APPLICATION FOR PERMIT TO DRILL						1. WELL NAME and NUMBER Drollinger 5-36-2-2W				
2. TYPE OF WORK DRILL NEW WELL <input checked="" type="checkbox"/> REENTER P&A WELL <input type="checkbox"/> DEEPEN WELL <input type="checkbox"/>						3. FIELD OR WILDCAT UNDESIGNATED

Newfield Production Company
Drollinger 5-36-2-2W
SW/NW Section 36, T2S, R2W
Duchesne County, UT

ON-SITE PREDRILL EVALUATION

Application for Permit to Drill Statement of Basis

Casing Schematic

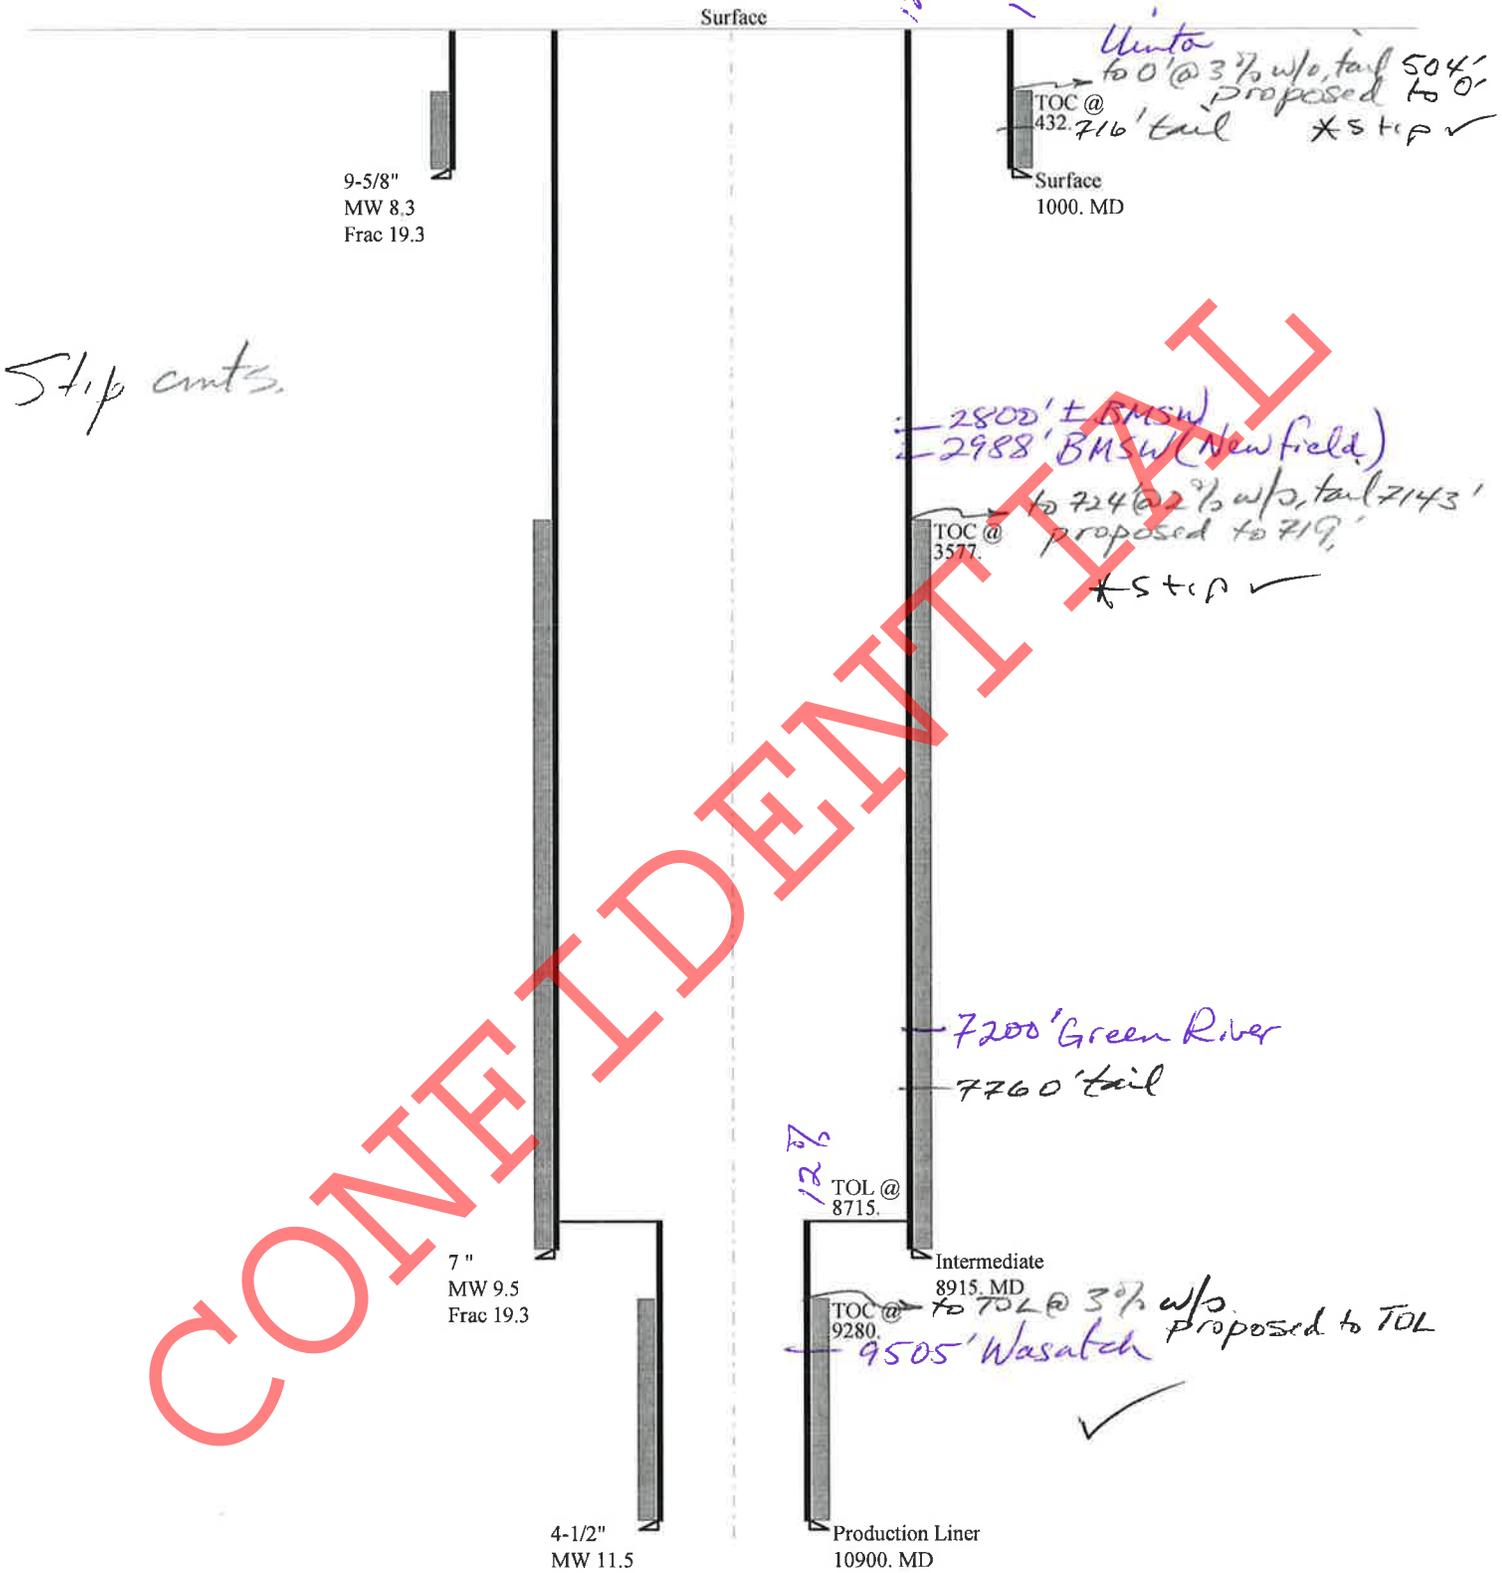
Well name:	43013511810000 Drollinger 5-36-2-2W	
Operator:	NEWFIELD PRODUCTION COMPANY	
String type:	Surface	Project ID: 43-013-51181
Location:	DUCHESNE COUNTY

Collapse is based on a vertical depth of 1000 ft, a mud weight of 8.33 ppg. The casing is considered to be evacuated for collapse purposes. Collapse strength is based on the Westcott, Dunlop & Kemler method of biaxial correction for tension.

Collapse is based on a vertical depth of 8915 ft, a mud weight of 9.5 ppg. The casing is considered to be evacuated for collapse purposes. Collapse strength is based on the Westcott, Dunlop & Kemler method of biaxial correction for tension.

For this liner string, the top is rounded to the nearest 100 ft. Collapse is based on a vertical depth of 10900 ft, a mud weight of 11.5 ppg. The Collapse strength is based on the Westcott, Dunlop & Kemler method of biaxial correction for tension.
